CITY OF ALBANY
LANDMARKS ADVISORY COMMISSION

AGENDA

Historic Review of Substitute Materials and Exterior Alterations (HI-01-12)

STAFF REPORT
Historic Review Exterior Alterations (HI-02-12)

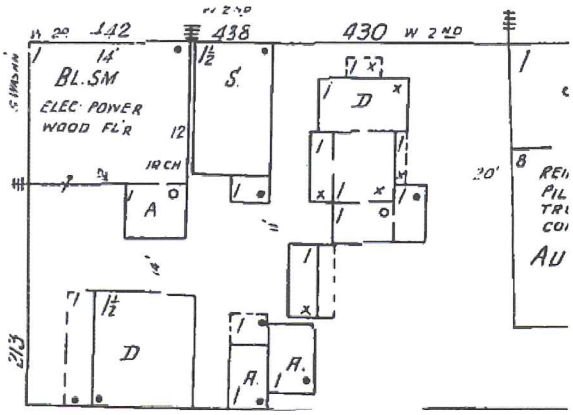
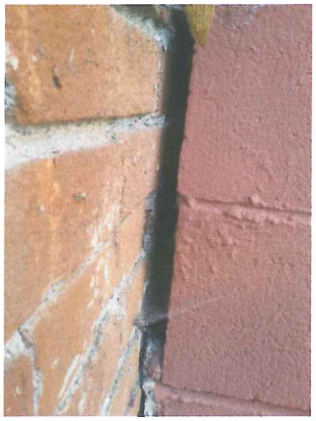
1.3 The windows proposed to be replaced are metal windows that appear to date to the 1960s. The thin metal frame design was used historically. The large "display window" size is compatible with historic commercial buildings. The glass in the metal windows was cracked and water was leaking into the building and security was compromised. The wood frame around the windows was dry rotted due to water damage. On the front façade, the applicant replaced the windows quickly due to water damage in the building and for building security. The cost to replace the glass was the same price as the proposed new windows. The applicant did not look at the price of new metal windows or metal-clad windows.

1.4 Proposal and Design Criteria for Substitute Materials. The applicant is proposing to replace the original metal picture windows with vinyl windows the same size and style, and utilizing the existing opening. The window stile and rail dimension are compatible with dimensions of wood windows in historic buildings.

1.5 The applicant will paint the windows to match the paint color of the windows on the main building (black). This will cover the vinyl material so they will resemble wood windows and be compatible with the materials and finishes on buildings in the Historic Downtown District.

1.1 The existing metal windows date to the 1960s and they are damaged beyond reasonable repair.

1.2 The vinyl windows will be installed in the existing window opening size and will not alter or cover any unique features of the building addition.

1.4 The windows will be painted to match the wood windows in the main building.

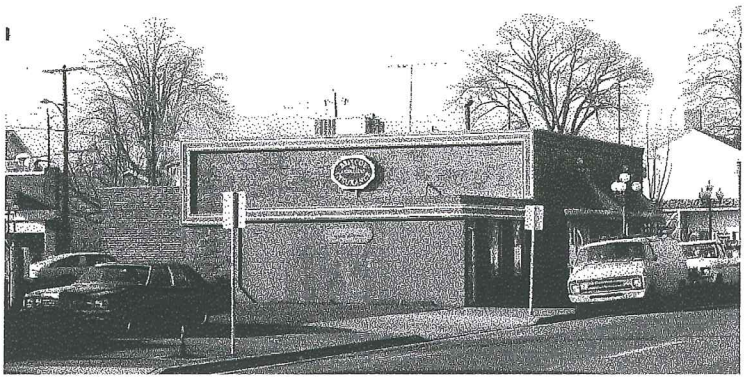
2.2 Cornice Band. A 14-inch by 4-inch wood board with a 2-inch by 4-inch board in the middle was wrapped around the top of the building and also around the edges of the east façade of the original building. The date of the band is unknown. The cornice band was not compatible with the 1907 building.

2.3 Due to deteriorated conditions and to repair water damage and paint the exterior, the band was removed from the addition and the main building. (See photos previous page and below.)

2.4 The applicant does not plan to put the cornice band on the east side of the original building to restore the original brick faced on the east side. The east side of the building addition is on the property line, and the cornice band cannot be installed without getting an easement.

2.5 The cornice board was functional on the front façade keeping water out of the CMU blocks. The objectives are to be compatible with the original building and features found in the district and to keep water away from the building and draining off the cornice band. The applicant's first choice is to install an A-frame "roof" on the front to cover the CMU block, finished with roof shingles, similar to that at Loafers. (See pictures below.) The mock frame in the picture is 14-inches tall and projects 12-inches. The second option is to provide a narrower A-frame design, extending only 6-inches with a smooth finish. The third option is to put the band back that was there or go with a recommendation of the Commission.

2.1 The cornice band was not an original feature of the 1907 building. A simple cornice board or A-frame design on the front will be compatible with the style of the addition and with the original 1907 building.

2.1 The cornice band design shall be decided by the Commission.

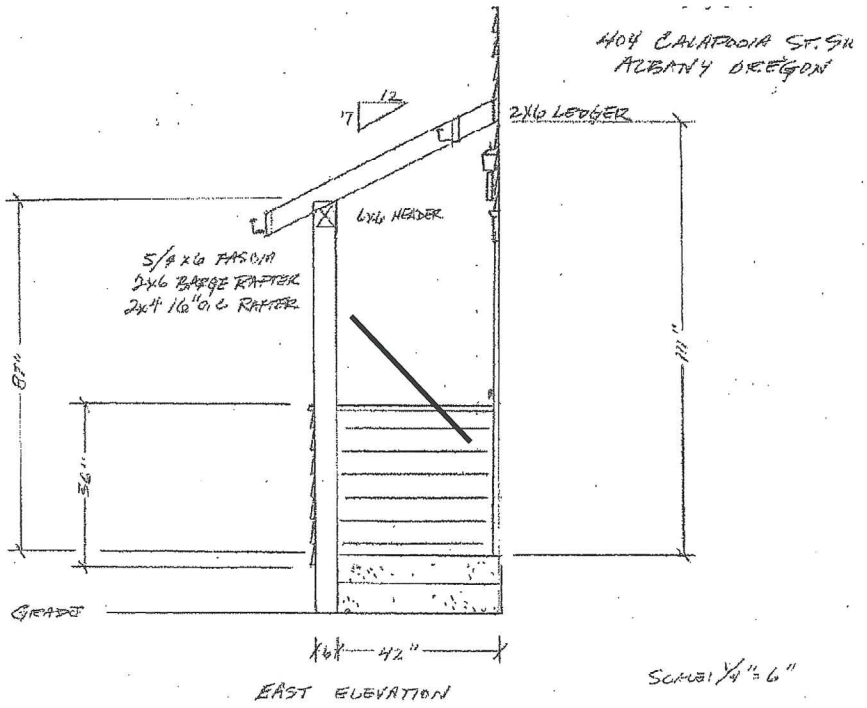
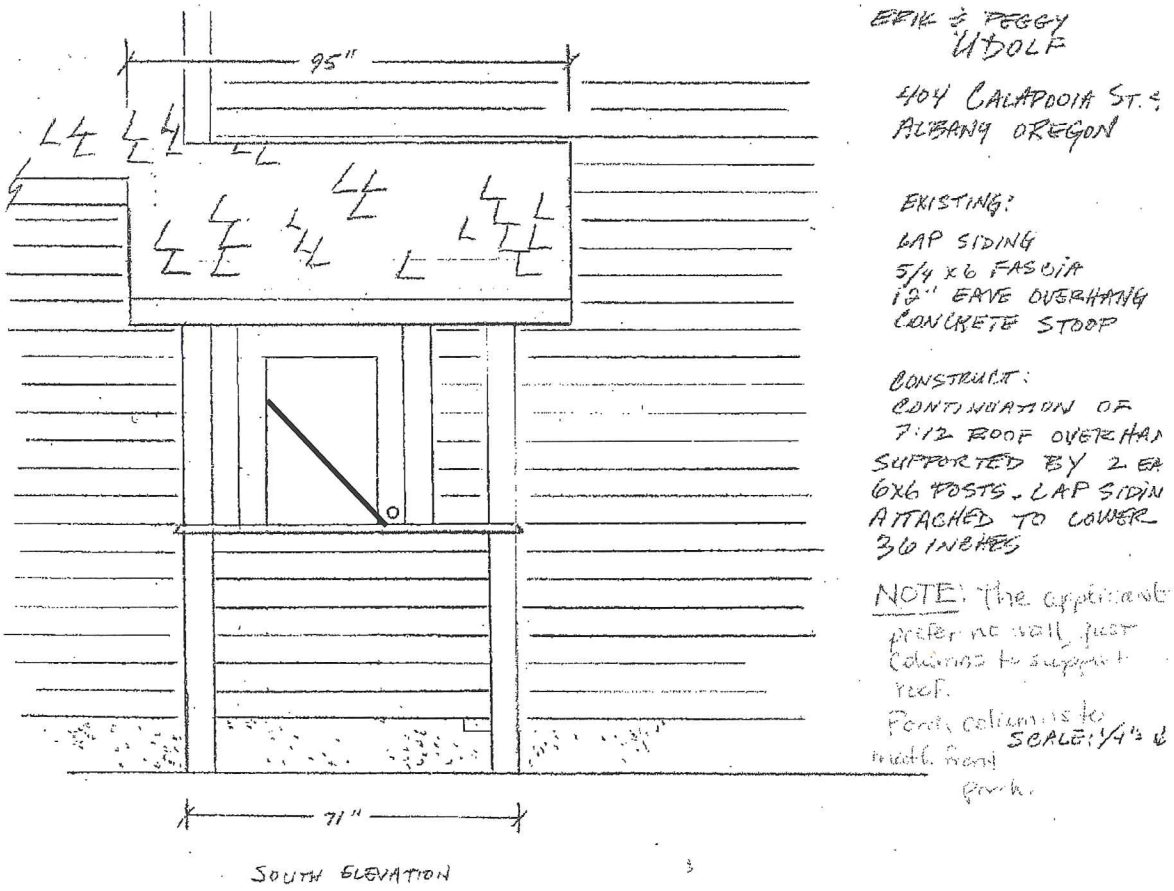
2. The applicant is proposing to extend the existing roof overhang over the door on the south side of the house. The overhang would extend out about three feet over the existing concrete landing. The slope of the overhang will match that of the existing overhang. The overhang would be supported with six-inch by six-inch posts that match the front porch post dimensions. The drawings show lap siding in the lower 36 inches to match the front porch. **The applicants prefer no wall** for easier accessibility to the side yard.

3. The proposed alterations are designed to be compatible with features on the house.

4. The proposed alterations will not remove or cover any character defining features or craftsmanship of the house.

1. The proposed extended roof overhang is compatible with the historic character of the house and of Albany's historic homes.

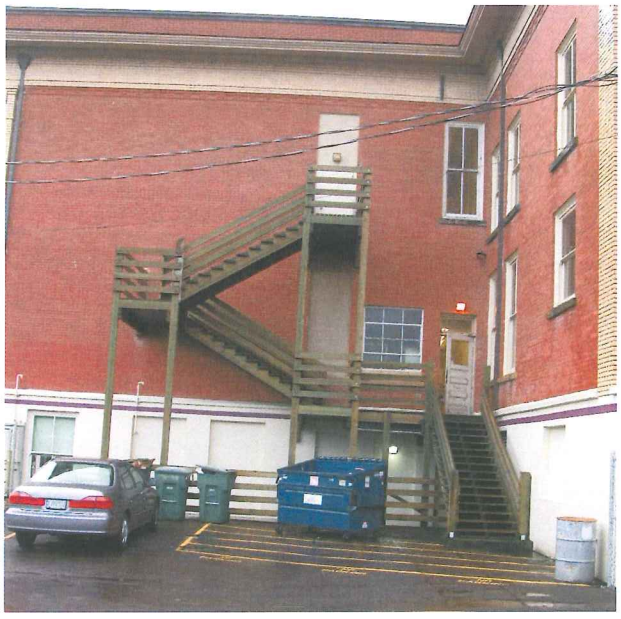
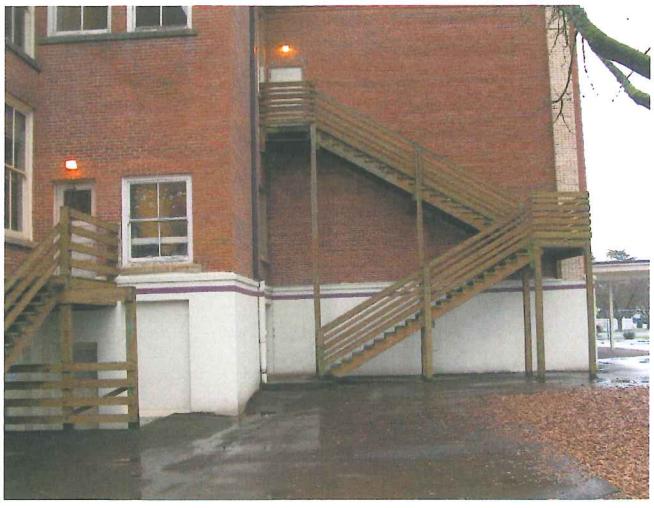
2. The original egress exit stairs were replaced long ago with pressure treated wood stairs as shown in the photographs.

3. Seismic improvements are being made to the school. The improvements include replacing the existing stairs with steel stairs that meet building codes and seismic standards.

4. The building has been used for educational purposes since it was constructed. There are minimum safety and egress standards for schools. The proposed alterations will bring the side and back egress stairs into compliance.

1. The stairs need to be replaced for safety reasons.
